**Re: Conditional Use Permit Amendment Request
Tax Map 202, Lot 16
350 Little Harbor Road
Portsmouth, New Hampshire**

This letter transmits a City of Portsmouth Conditional Use Permit Amendment request for an application previously approved by the Planning Board at its regularly scheduled meeting on September 15, 2016. This amendment is being requested as the approved project is approximately 90% complete and grading, landscaping, and finish site work will begin shortly. Upon review of the landscaping and final grading, it was determined that some minor changes be requested, most of which would be characterized as "landscape" in nature. This request does not include any changes to the residential structure or any accessory structures that were previously approved. The requested changes are outlined as follows;

Nalewajk Residence

Site Landscape & Planting Plan

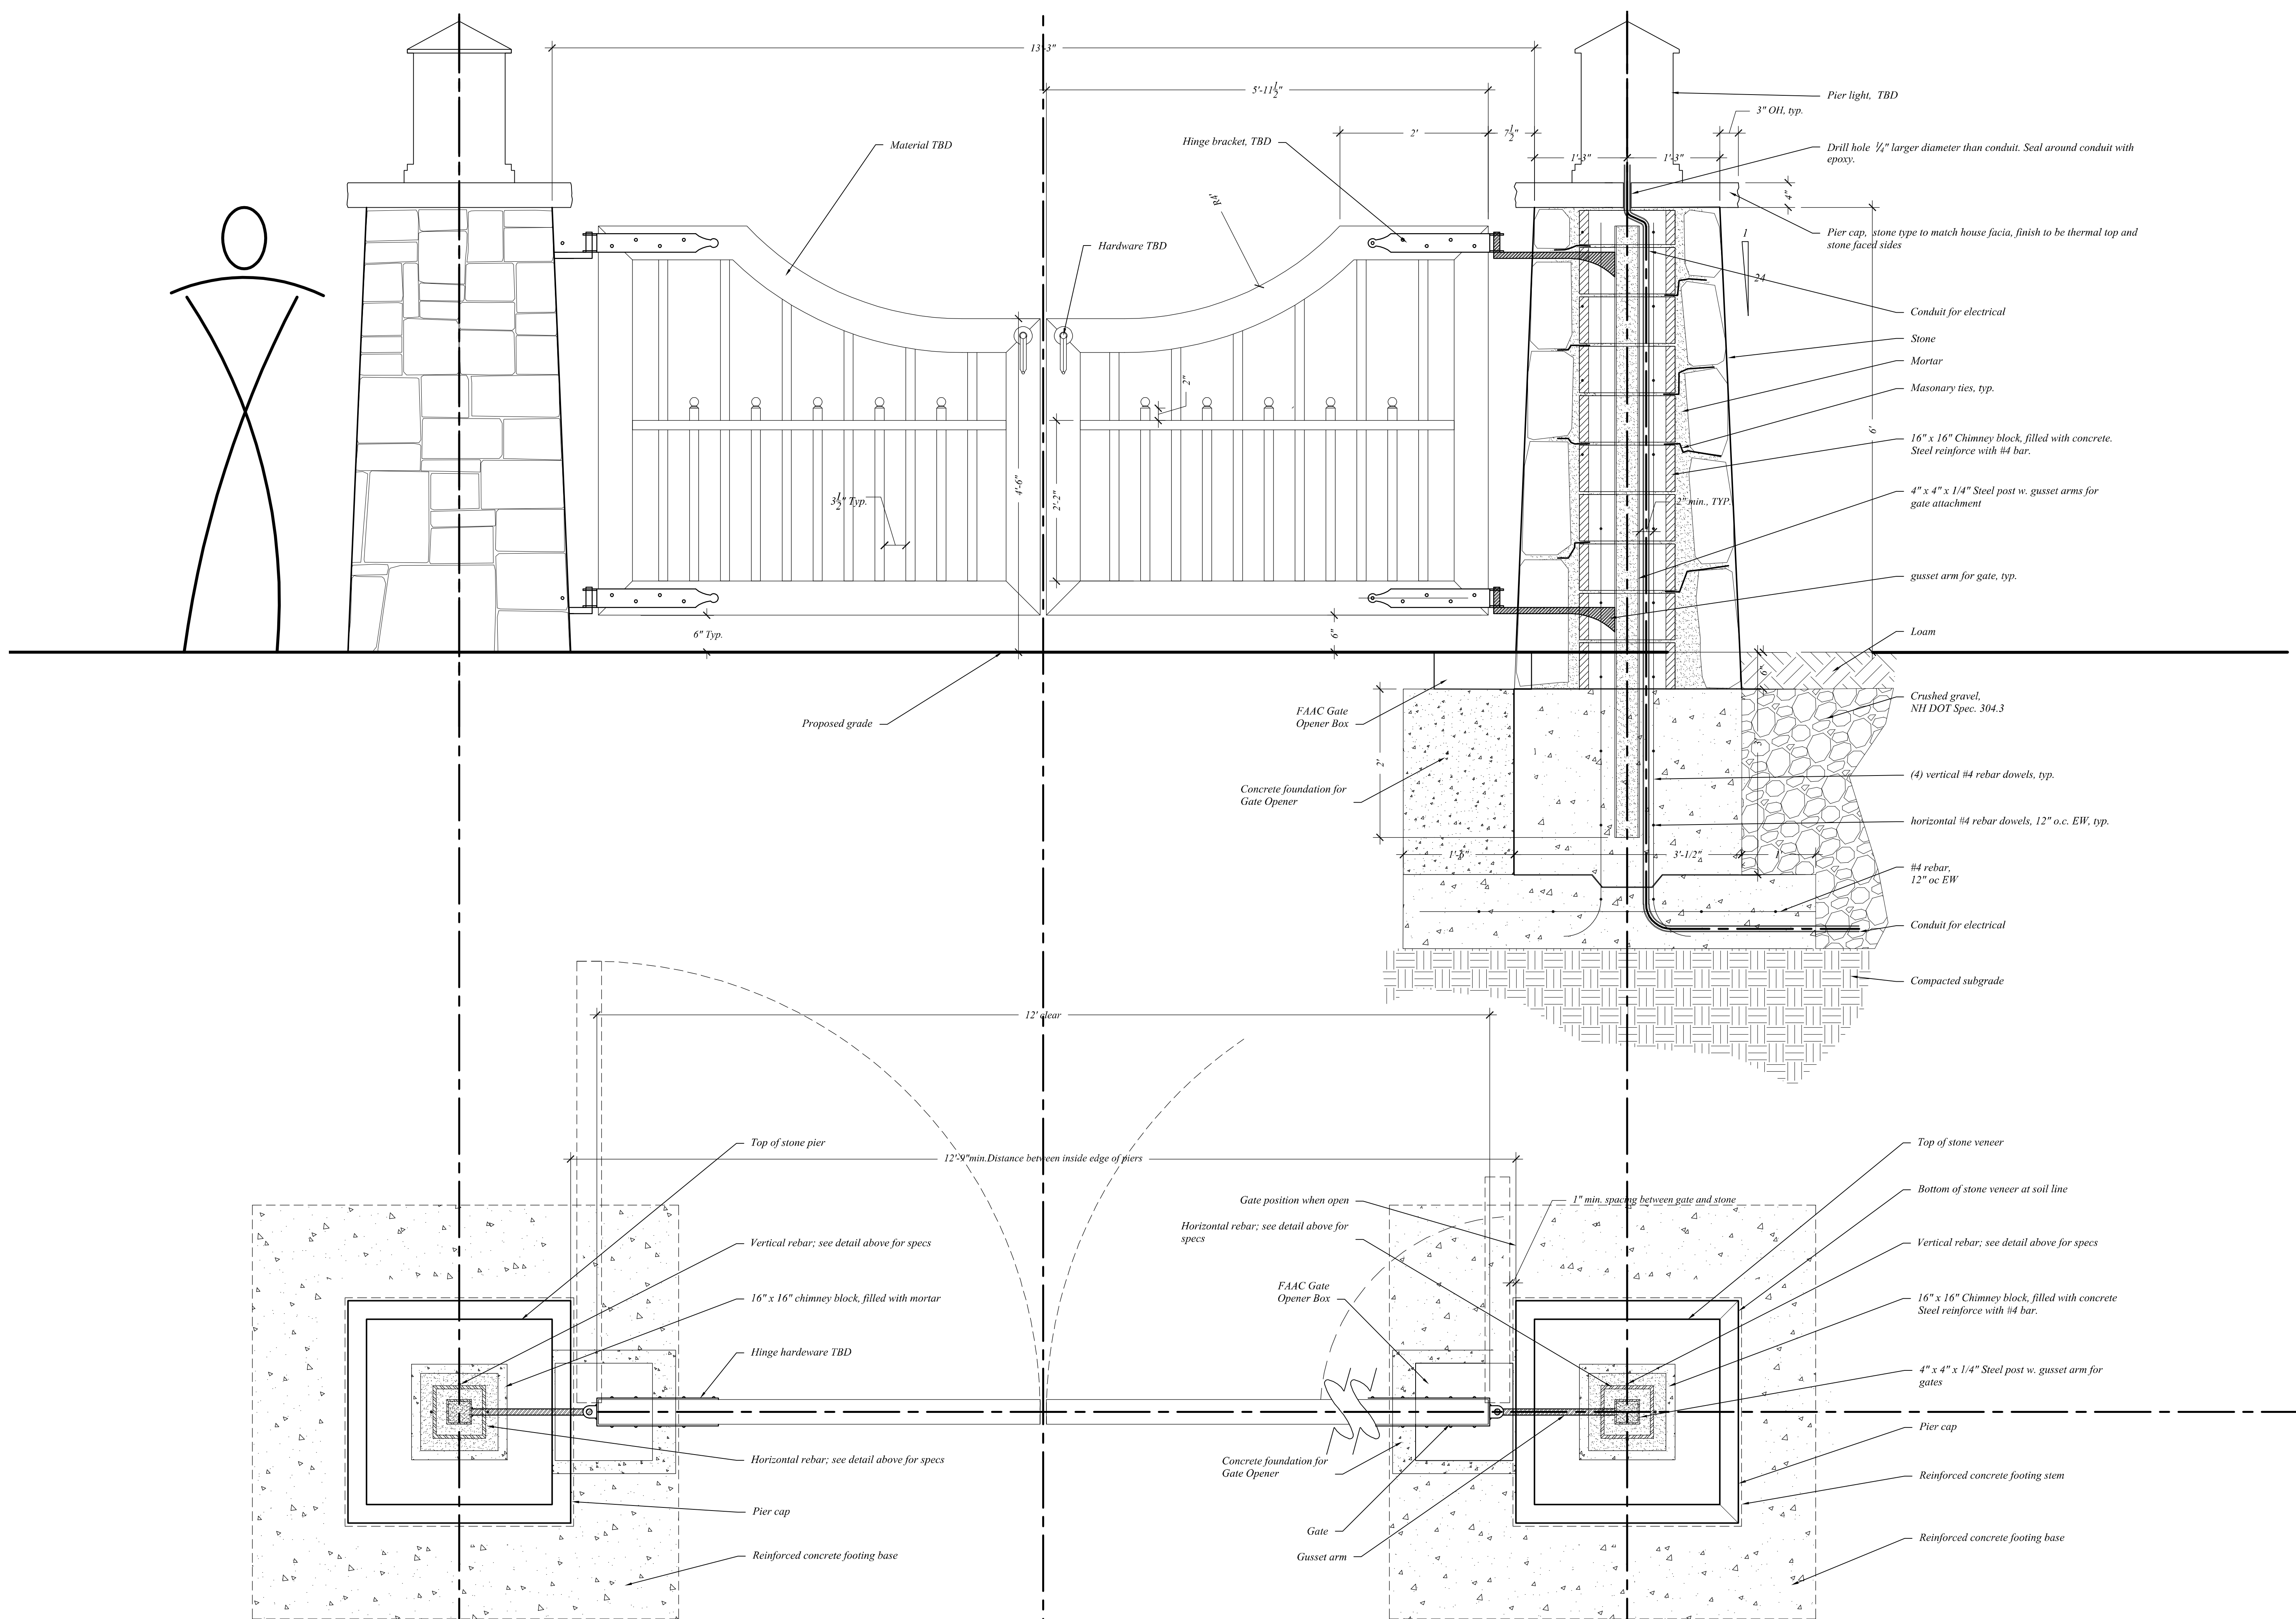
- Proposal of a security gate on the western side of the subject property associated with the legal access to the property from Martine Cottage Road. The gate is needed as historic use of the neighborhood (in particular the property known as Creek Farm), and historic use of Martine Cottage Road (by vehicles and pedestrians), has created a situation where the public is consistently entering the private property. The historic use of Martine Cottage Road and Creek Farm Road created a "circle" or "loop" in which vehicles and pedestrians could travel through the subject property (please see the attached Aerial Photo Exhibit and Photo Log). Subsequent to the purchase of the property, and re-development of the property, the owners have had to repeatedly ask the public to cease trespassing onto the property. The combination of the previously approved gate on the eastern side of the parcel, and the proposed gate on the western side of the parcel, will provide the property owners with the security they desire.

- Proposal of 255 linear feet of buried electrical conduit from the residential structure (under construction) to the location of the proposed gate. Electrical power to the gate is needed for operation, as well as a security camera that will be installed on the gate (255 sq. ft.).

- Proposal of 740 linear feet of buried irrigation line need to provide water to proposed landscaped areas/landscape plantings on the parcel, located as much as 180 feet from the residential structure. The irrigation line contains hose bibs, which are garden hose fittings where a traditional garden hose can be attached. Additionally, the irrigation line will allow for “soaker” hose to be attached to provide drip irrigation to the proposed landscape plantings. The drip irrigation will help insure the survival of the landscape/rain garden plantings and can be placed on a timer to water only when needed, an excellent water saving technique.

* PLAN REVISED 9/25/18 WITH CALL OUT NOTES RELATIVE TO CHANGES FROM 9/15/16
CITY OF PORTSMOUTH CONDITIONAL USE PERMIT APPROVAL. THE PLAN INTENT IS TO SHOW CHANGES FOR A CONDITIONAL USE PERMIT APPLICATION AMENDMENT REQUEST.
TOTAL AREA OF DISTURBANCE : 1,067 SQ. FT.
